January 24, 1992  
LD-92-006

Docket No. 52-002

Subject: Response to NRC Requests for Additional Information

RESPONSE TO NRC REQUESTS FOR ADDITIONAL INFORMATION  
PLANT SYSTEMS BRANCH

Figure  
11.2-1

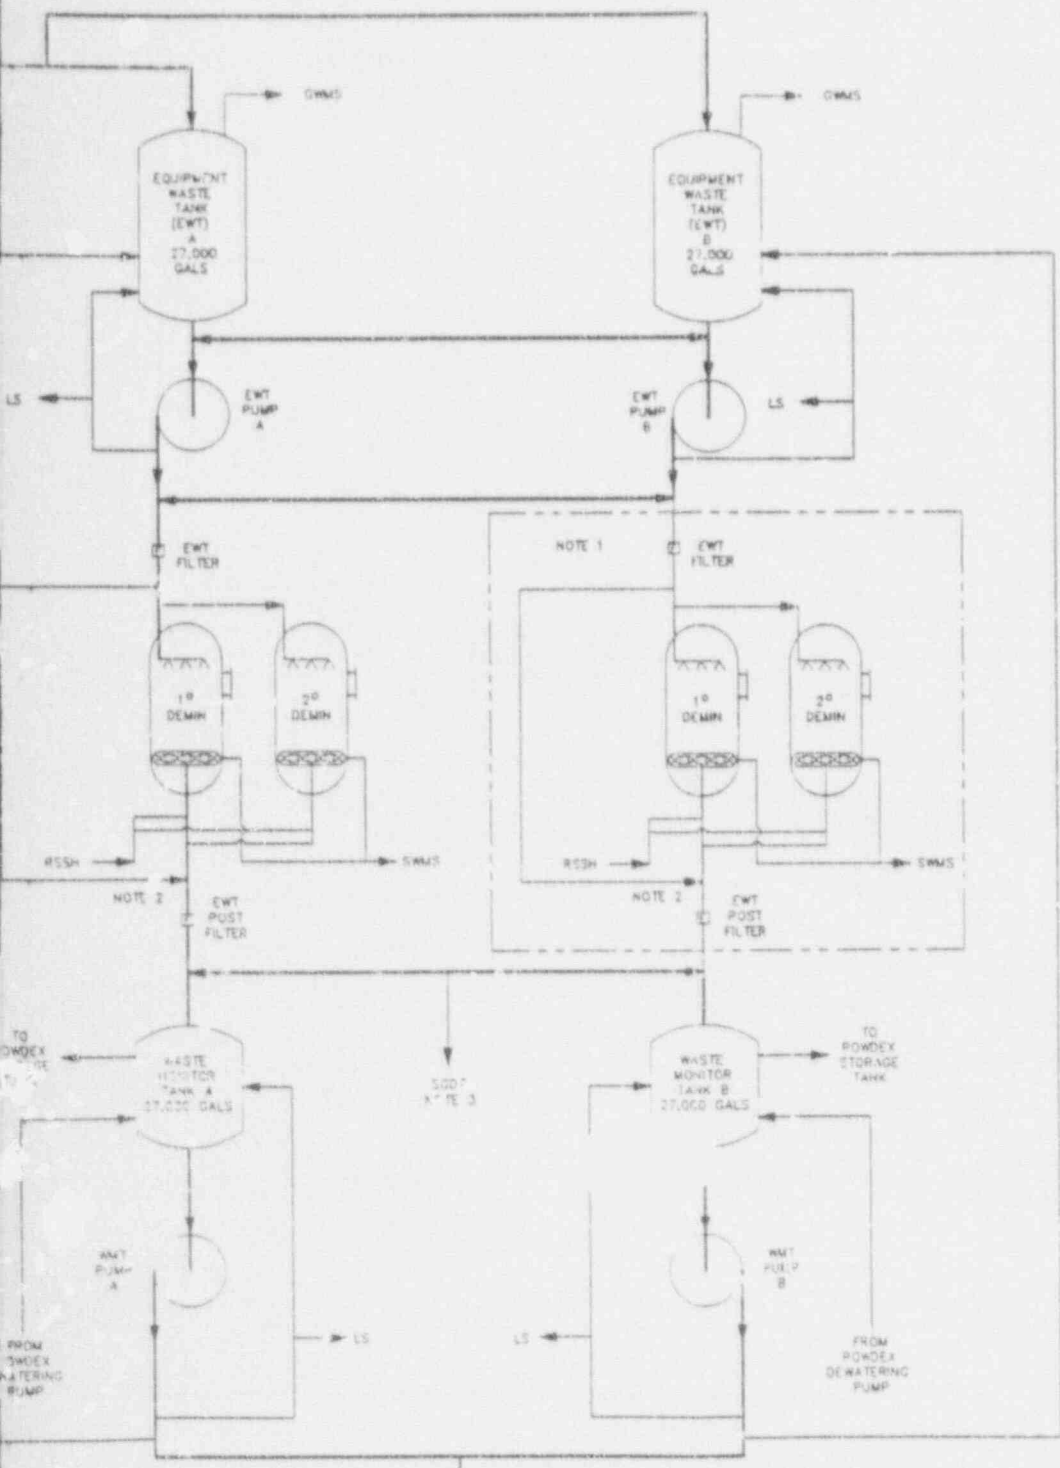
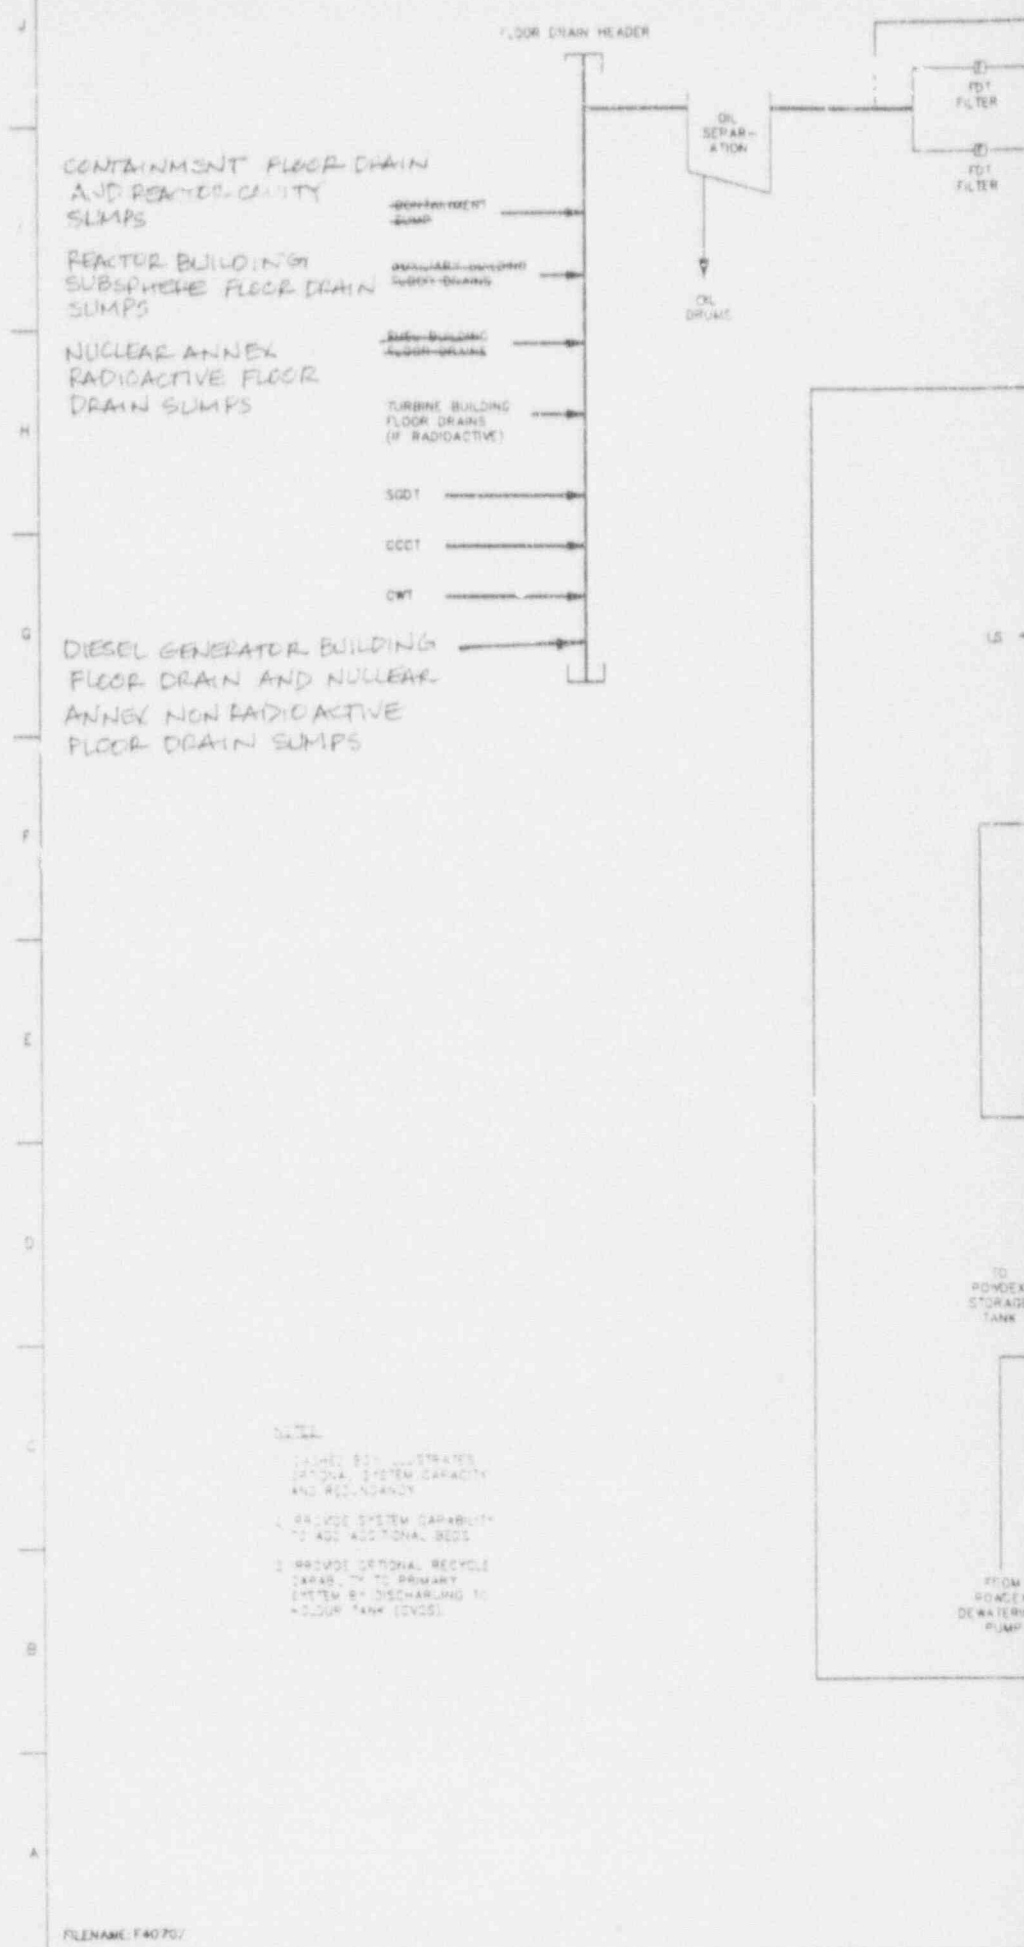
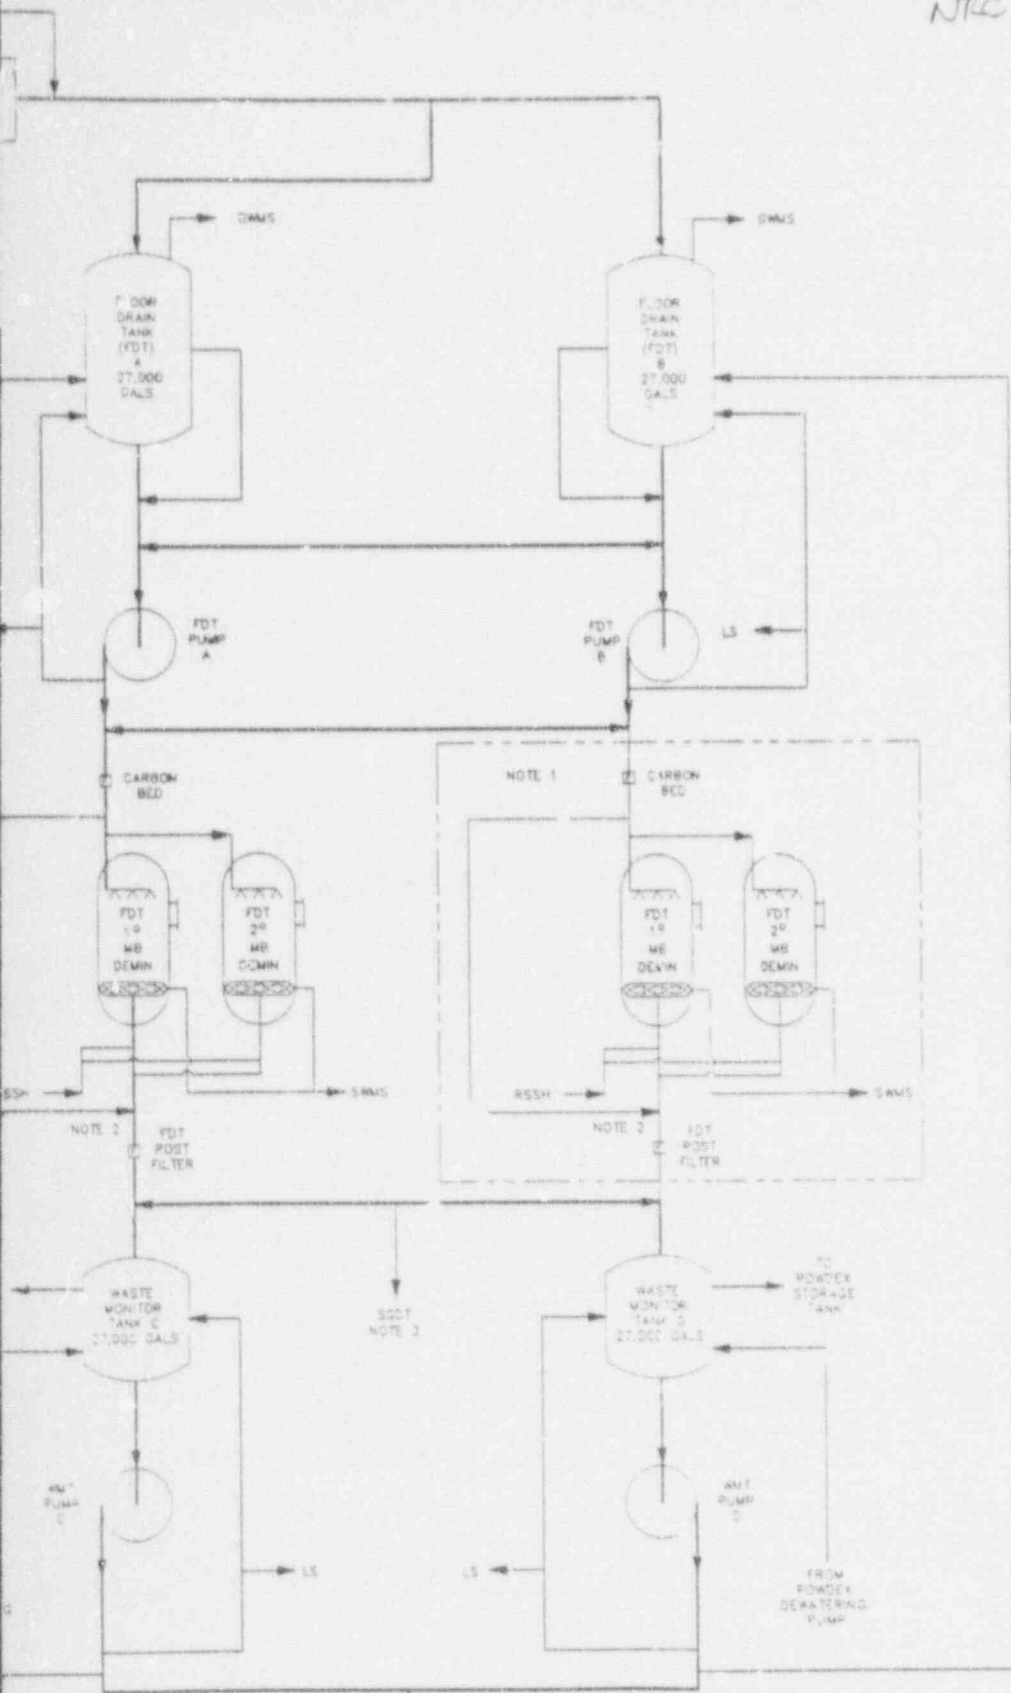
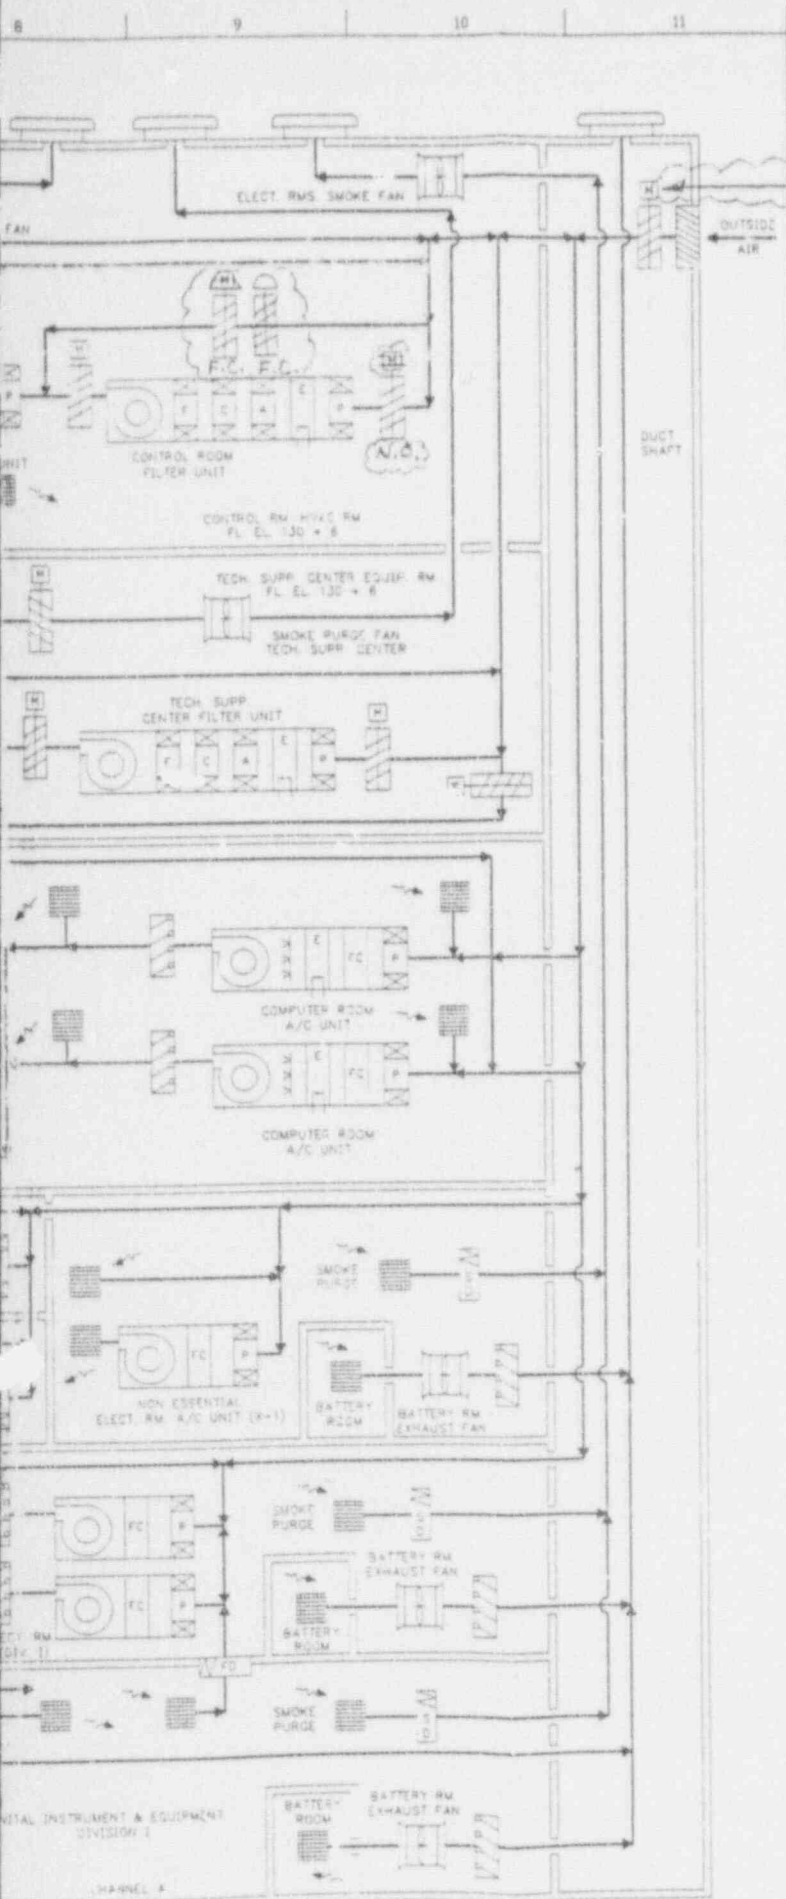
- d. Figure 11.2-1 refers to Auxiliary and Fuel Building discharges to the equipment and floor drain headers. This is not consistent with the figures in Section 9.3.3 which refer to Nuclear Annex and subsphere sumps. Verify that the references to the Auxiliary and Fuel Building discharges are in fact the discharges from the areas identified in Section 9.3.3.

- d. Figure 11.2-1 will be revised to accurately reflect the names of the designated inputs to the floor drain waste header and tanks. These revisions will be consistent with the text and figures of CESSAR-DC Section 9.3.3. These revisions will be included in a future amendment to the System 80+™ CESSAR-DC.

NUCLEAR ANNEX CONTROL BUILDING  
AIR FLOW DIAGRAM  
FIGURE 9.4-2

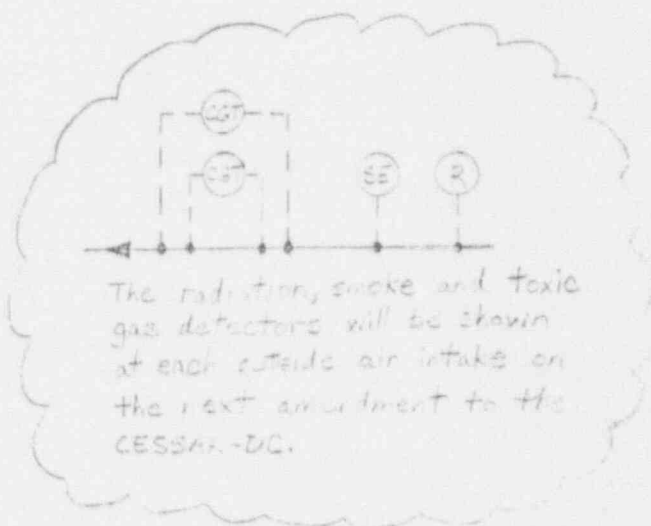
- e. What are the design values for air flow rates for all flow paths in the control building for normal and accident conditions? Your response should include areas shown in Figure 9.4-2, such as the essential electrical room, for which normal inlet flow is indicated but for which the exit flow path is not identified.

- a. The Control Room HVAC System is revised to provide two isolation dampers at the outside air intakes. A revision to CESSAR-DC Figure 9.4-2 is attached.

- b. The Control Room HVAC System is revised to provide two air operated dampers designed to fail closed in the filter train bypass. A revision to CESSAR-DC Figure 9.4-2 is attached.

- c. The smoke, toxic gas and radiation monitors for the Control Room HVAC System are shown on the attached mark-up of Figure 9.4-2.
- d. Yes, they are the flows through the recirculation units for their respective areas.

The radiations, smoke and toxic gas detectors will be shown at each outside air intake on the next amendment to the CESSAR-DC.

FIRE PROTECTION WATER DISTRIBUTION SYSTEM  
FLOW DIAGRAM

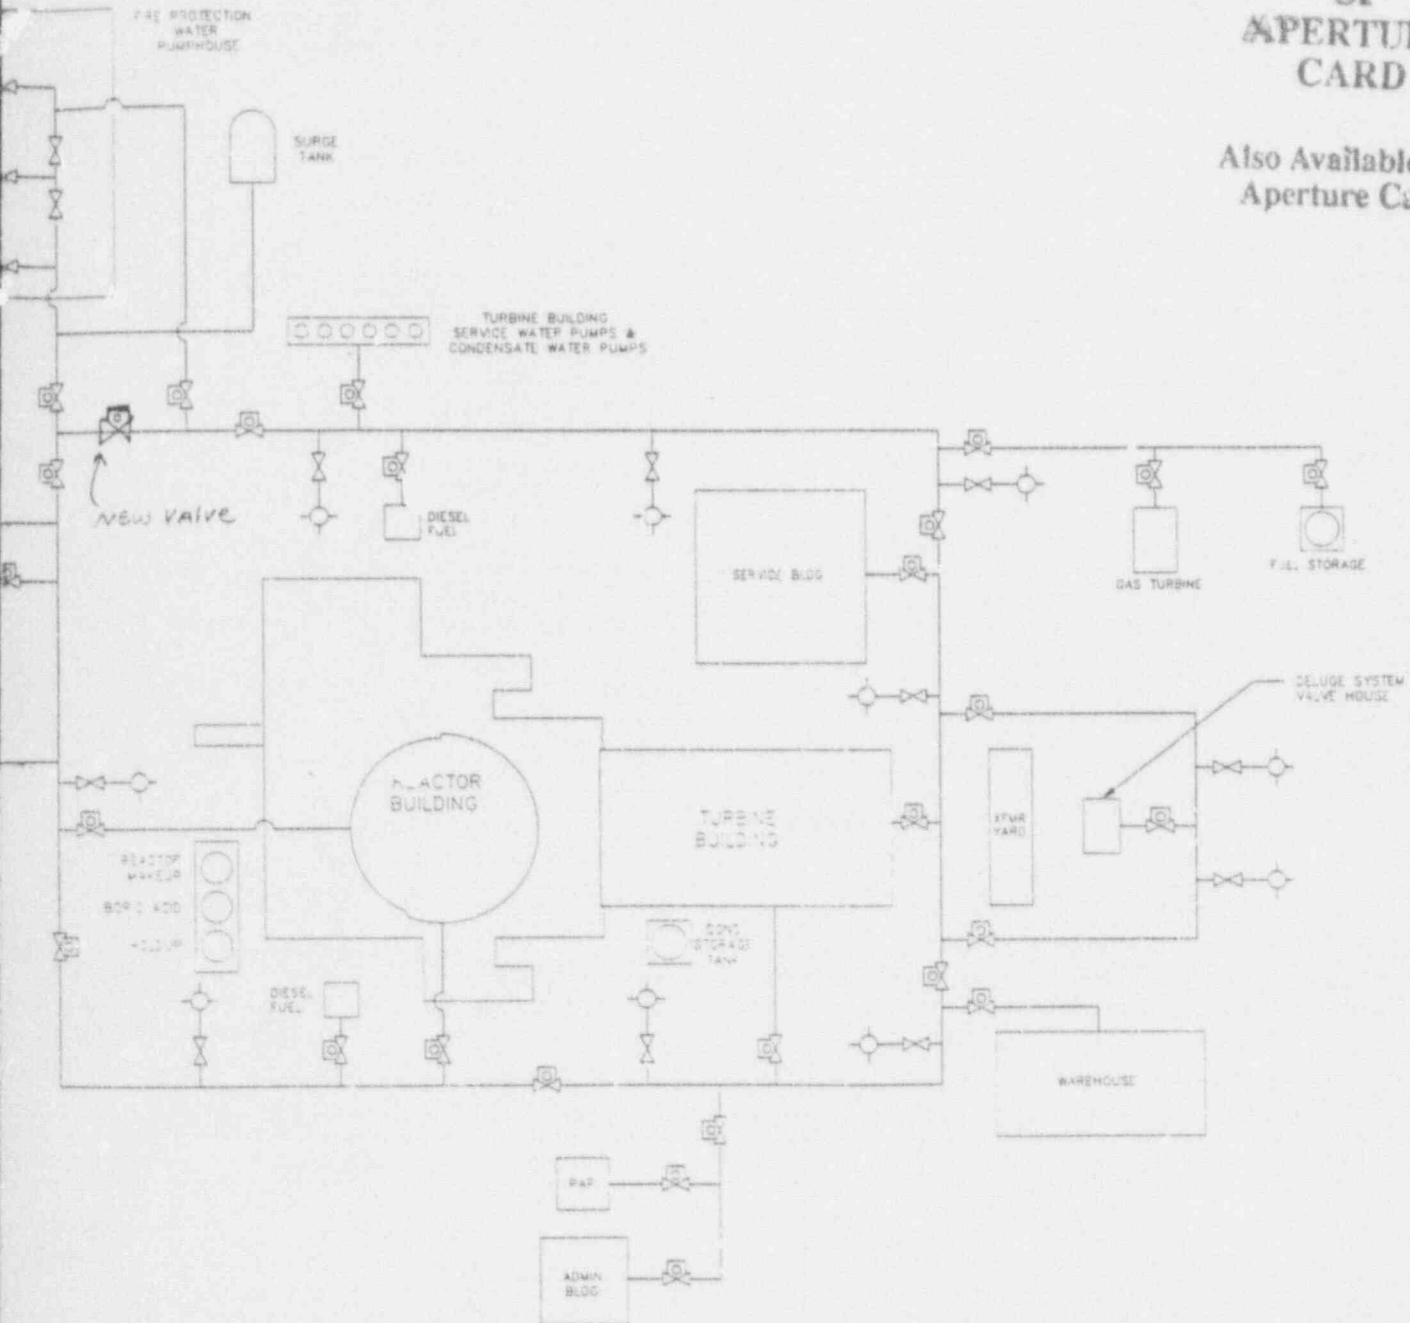
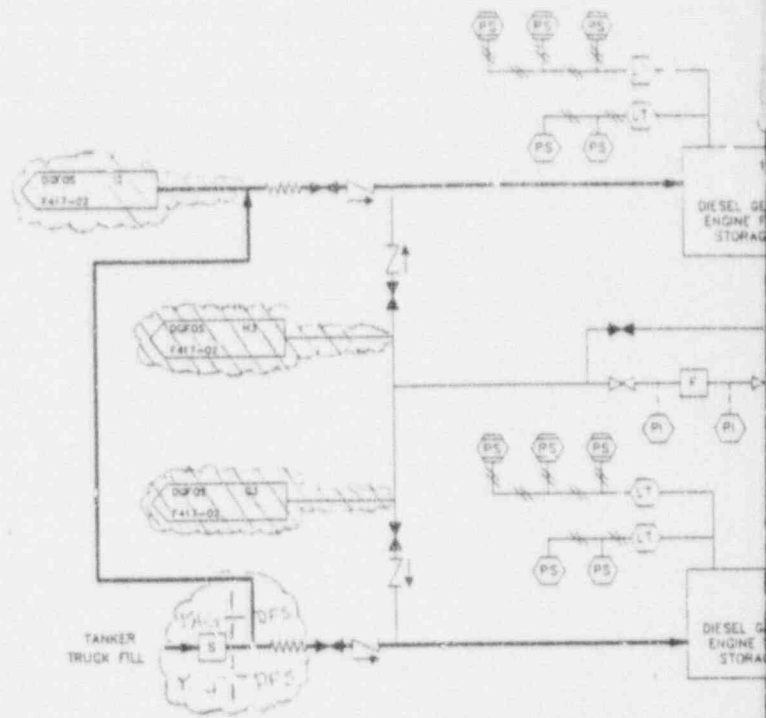
In reviewing Figure 9.5.1-1, Fire Protection Water Distribution System, it is noted that a single pipe break in the piping section between the two fire pump discharge lines could render the total fire system inoperable. This condition exists, under limited conditions, at other places on the underground fire water loop (i.e., loss of fire water to onsite structures). This does not seem to be consistent with the criteria discussed in Section 9.5.1.5.2, Water Distribution System, Hydrants, and Hose Houses.

An additional valve will be added in the piping section between the two fire pump discharge lines so that no single break could render the total fire system inoperable. A marked-up copy of Figure 9.5.1-1 showing this additional valve is attached. This revision will be included in a future CESSAR-DC update.
